**Request ID:** CDP(A)-2387-21

**Project Name:** Orchard Pointe CDP

**ORCHARD POINTE**  
**COMPREHENSIVE DEVELOPMENT PLAN**  
**AMENDMENT 17**  
**LOT 1 OF CSM 10317 LAND USE**

Application: CDP(A)-2387-21 & CS-2388-21  
Property Location: 6220 Nesbitt  
Review Date: May 26, 2021  
*Planning Staff Review #1*

**PRELIMINARY DANE COUNTY  
CERTIFIED SURVEY MAP #**

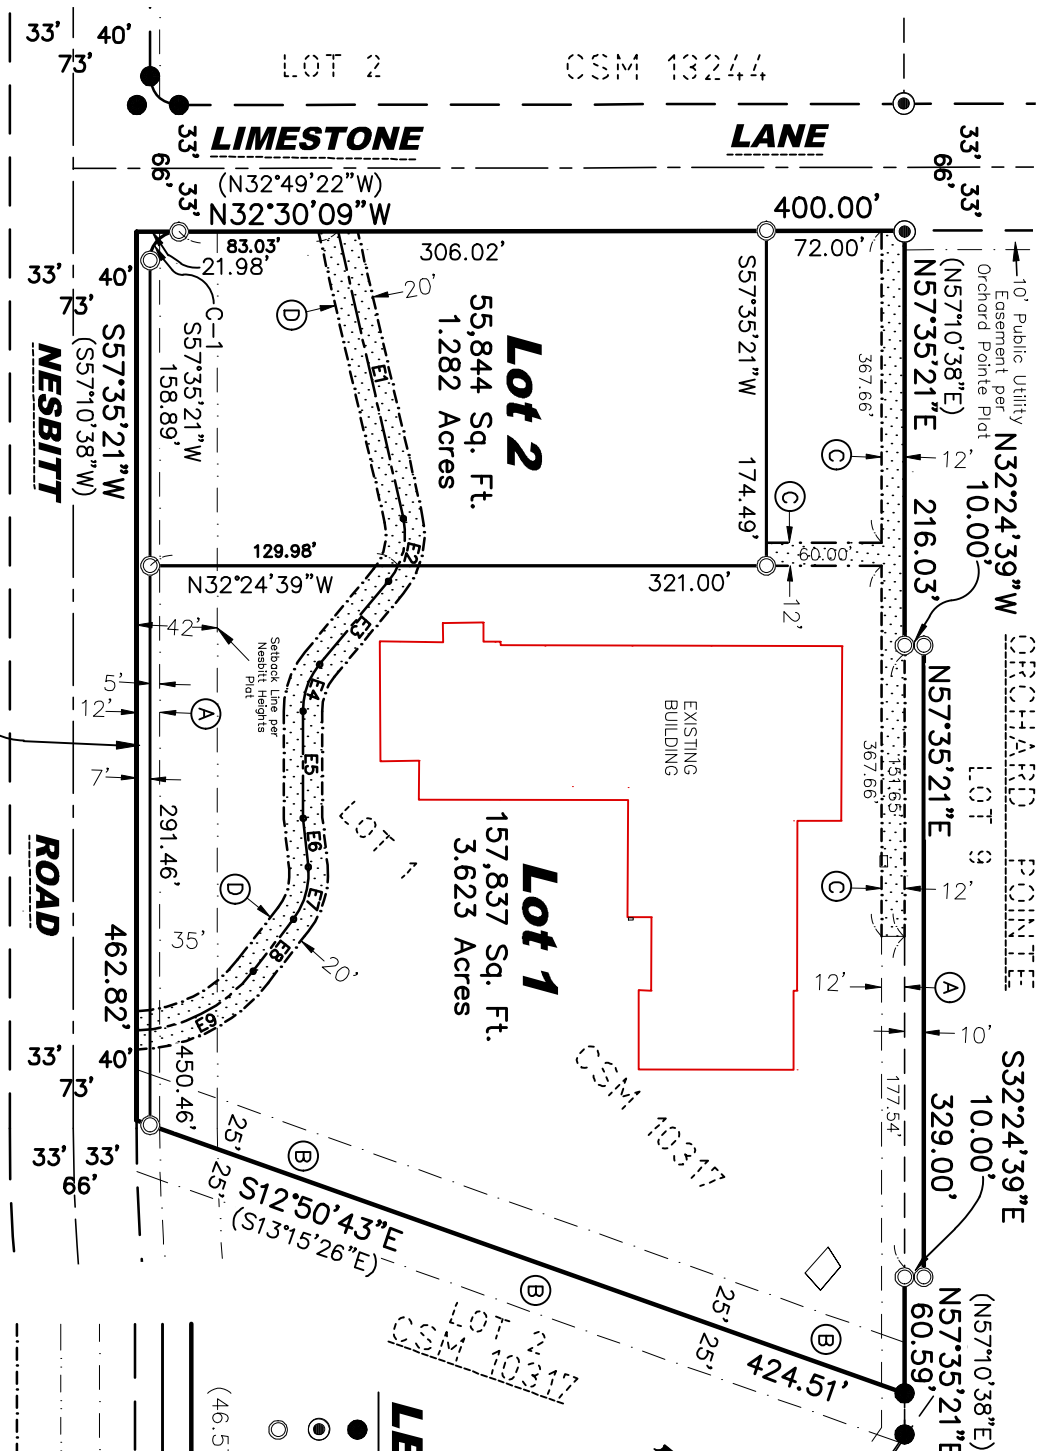
6. What is the purpose of the jog in the proposed lot line? **(The jog was eliminated)**

4. The Subdivider shall confirm utility easement requirements with utility companies (MG&E, AT&T, and Charter) and show all necessary easements on the CSM. **(The utility lines currently serve the property from the East side of the property through the existing 12' easement per Document No. 1949106 and continue West to the existing transformer, CATV pedestal and telephone pedestal. We have extended the 12' easement West to Limestone Lane and provided a 12' easement South to serve Lot 2. The CSM, Existing Site Plan and Proposed Site Plan are being submitted to MG&E, AT&T, and Charter for their review and approval of the easement locations.)**

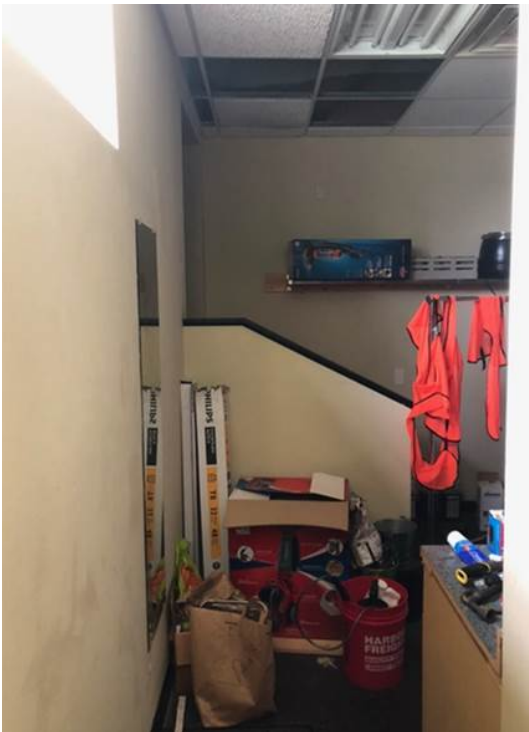
1. Will lots #1 and #2 have shared access to the rear? At present, we have access to the back of the building. The gravel lot that provides that access will be in Lot #2 if the property division is approved. Will we still be able to access Lot #1 from ~~Hardrock~~ (typo) Limestone (as we can presently)?

Taking away access makes it more difficult to navigate parking lots with larger equipment. Further, if access to Lot 2 (from Lot 1) is taken away and traffic cannot exit on ~~Hardrock~~ (typo) Limestone, we would only have only one access point to the Lot #1 parking lot. Any incident blocking that single exit point could potentially block up to 100 cars from leaving the parking lot.

The same thing would apply to Lot #2 (How many access points will they have to their lot?).

If access from lot-to-lot is allowed, it provides better access for larger emergency vehicles- and multiple points of egress for other vehicles using the lot. **(An emergency cross-access easement encumbering and benefitting both Lots 1 and 2 connecting the existing driveway access to both Nesbitt Road and Limestone Lane has been added to the Certified Survey Map. The rights and conditions for this easement will be granted by separate instrument that Charden Properties, LLC attorney will prepare and submit to the City of Fitchburg for review and approval. This easement is also shown on the Proposed Site Plan as part of the CDP Amendment)**

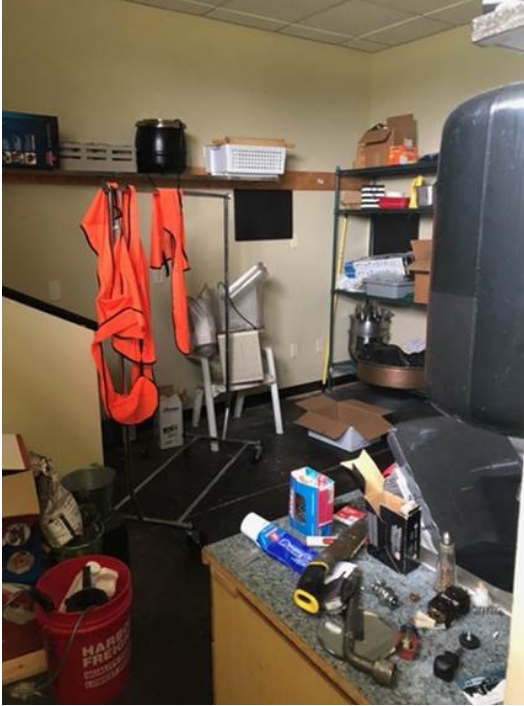
2. Another thing that has always puzzled me about the Pancake Café property is the back exit. It is marked as an emergency exit on the inside. However, if anyone ever needed to use that exit, they would not be able to go very far. Those that are less-than-nimble would not be able to get out of the “well” constructed around the door. Inside, the situation isn’t much better – emergency egress is not ADA compliant. Is there a way to address the grade so that this “emergency exit” can actually be used as an exit? I have provided pictures (below): **(We reviewed the “well” and propose that a 5-foot wide opening be sawcut opposite the door opening and a slope meeting ADA standards be grading to daylight existing ground toward Limestone Lane.**

**Inside the building, Charden Properties, LLC will work with the Fire Dept. to build a ramp or other acceptable ADA compliant solution to existing to the exterior door opening.)**
